RECEIPT DATE: 10/13/17 **ONSITE SEWAGE DISPOSAL SYSTEM**P 562301APPROVAL DATE: 12/7/17 **PERMIT: CONSTRUCTION**

PROPERTY ADDRESS: 14665 Red Lion DriveSUBDIVISION: Red Lion EstatesLOT: 16 TAX ID: 04-374649CONTRACTOR: South Carroll BackhoeEMAIL: scbackhoe@comcast.netCONTRACTOR ADDRESS: 4410 Salem Bottom Road, Westminster, MD 21157PHONE: 410-596-3618PROPERTY OWNER: Salvatore and Estela Valenziano

RE: Red Lion Estates
Lot 16
Revised Perc Cert & BAT Plan

ONSITE SEWAGE DISPOSAL SYSTEM DESIGN PLAN

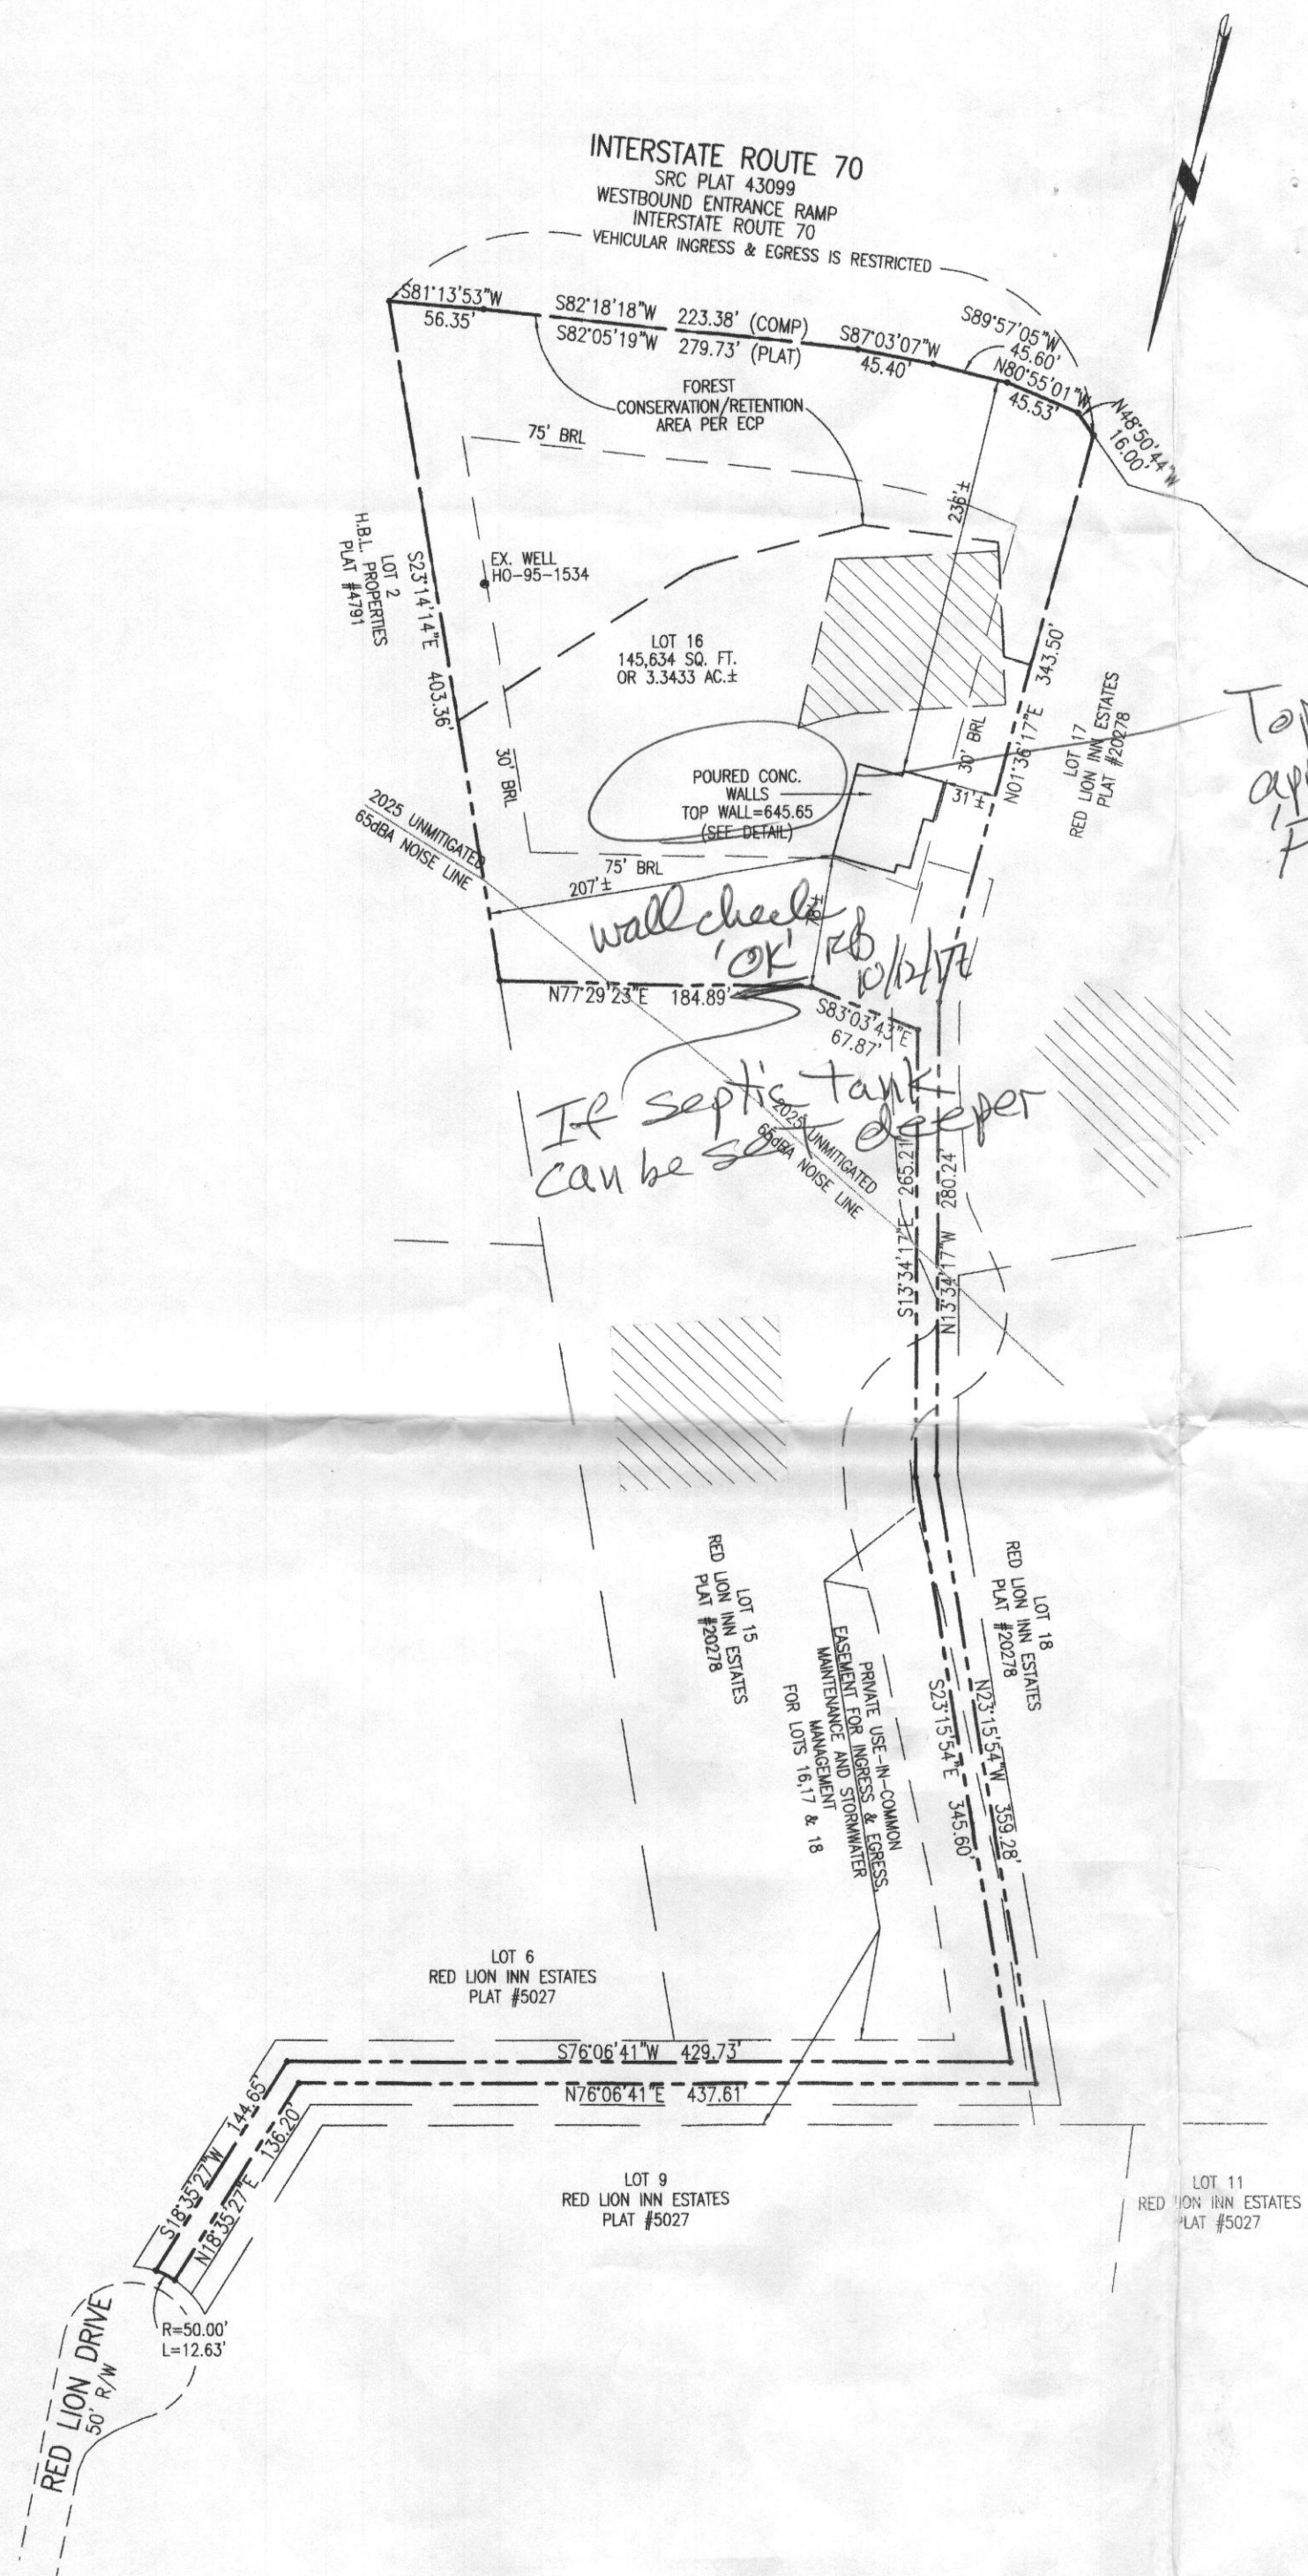
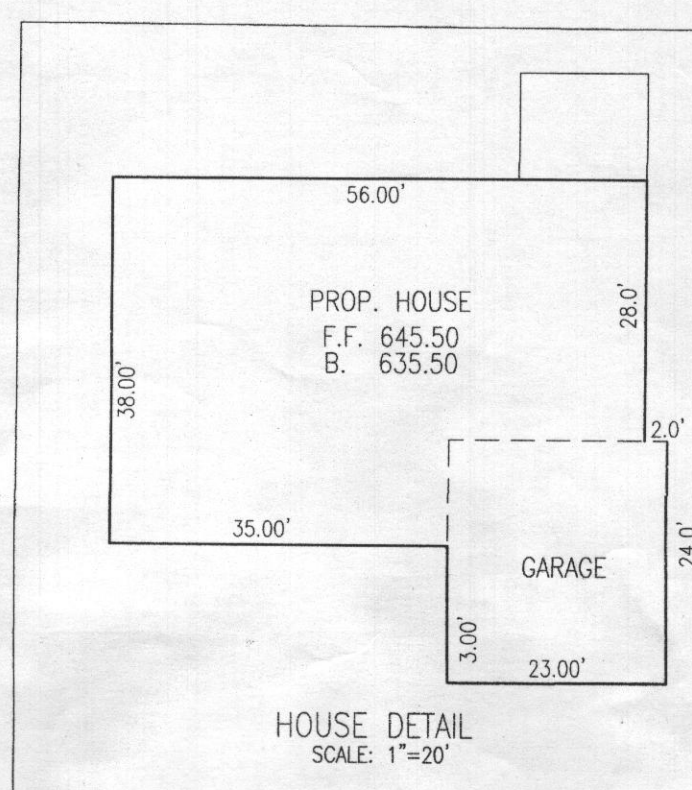
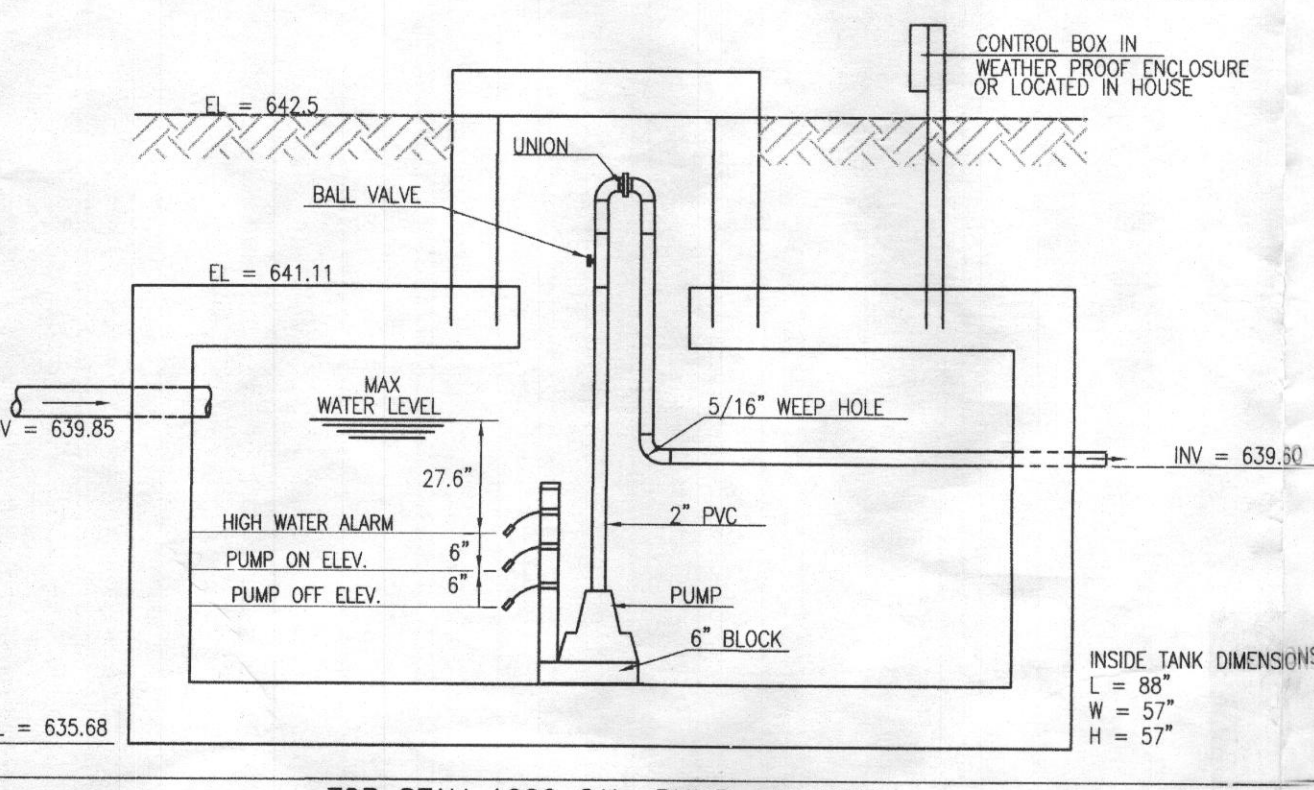
Here are my comments for the BAT Plan:

- All existing structures on the property must be shown on the plan. There is an existing shed on the property that is not being shown on the plan.
- Well Certification Statement needs to be added to the plan. The statement must include the tag number and a signature certifying it was field located and accurately shown.

- All perc holes must be labeled with their corresponding test number.
- Add the note: The property line closest to Perc Hole #59 must be staked prior to system installation.

- The cross-section of the pump chamber is not acceptable. We need to see a better pump tank cross-section from the tank manufacturer.
- The pump tank model being chosen must be shown on this plan.

- The Friction loss calculations are incorrect and must be corrected.
- The Ball Valve uses the Gate Valve coefficient in the friction loss calculations. If the gate valve is being installed then it must be labeled as a gate valve. If the Ball Valve is being installed then the Ball Valve coefficient must be used in the calculations.

REMARKS: Hi Robert, revised to reflect your comments Submitted for review and approval. Thank you!

WALL CHECK DRAWING
LOT 16
RED LION INN ESTATES
PLAT No. 20278
TAX ID: 04-374649
14665 RED LION DRIVE
FOURTH ELECTION DISTRICT
HOWARD COUNTY, MARYLAND
SCALE: 1" = 100' MAY, 2017

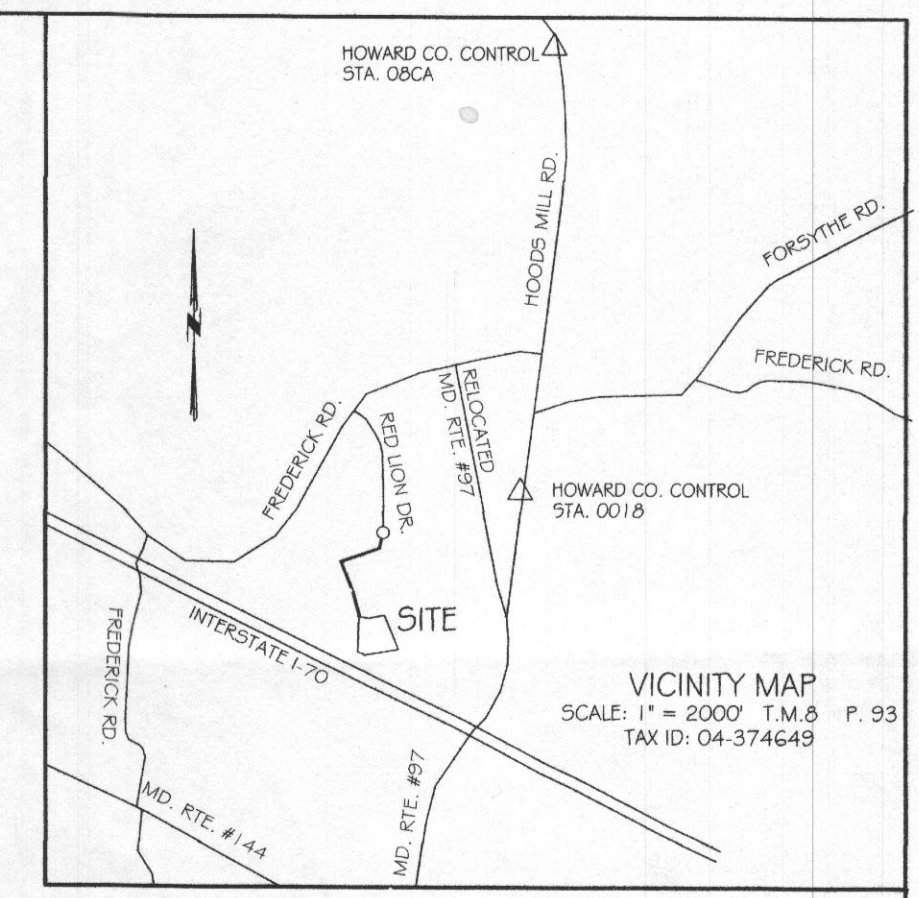
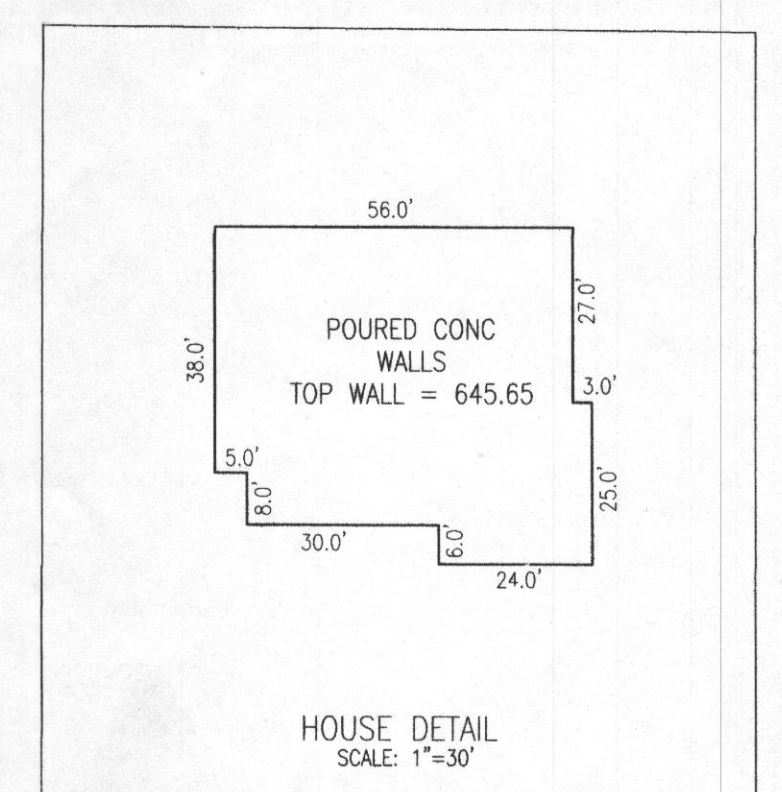
wall check OK RB PL/AT
If septic tank can be set deeper
